Specification Change for the Short Bars on the Terminal Block Portion of the General-Purpose AC Servo Amplifier

MR-J4-500A/B(-RJ)

Figure 1. Dimensions of MR-J4-500_ (with the front cover opened)

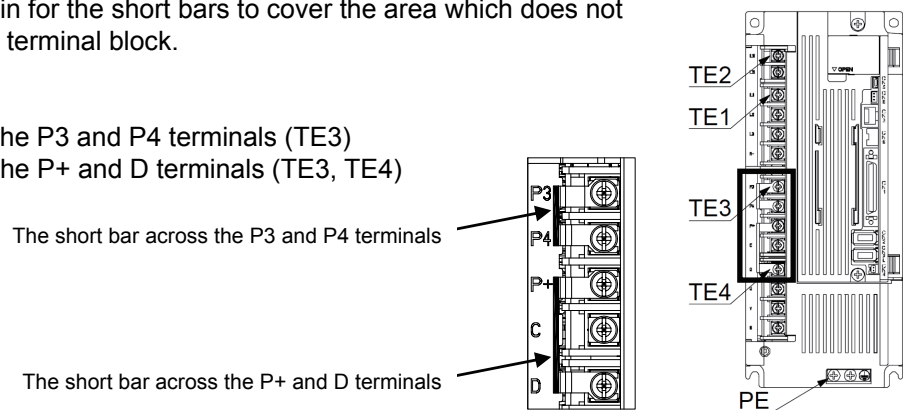
Use of the insulating resin for the short bars to cover the area which does not come in contact with the terminal block.

- The short bar across the P3 and P4 terminals (TE3)
- The short bar across the P+ and D terminals (TE3, TE4)

Before change	After change
The short bar across the P3 and P4 terminals (TE3)		Covered with the insulating resin
The short bar across the P+ and D terminals (TE3, TE4)		Covered with the insulating resin
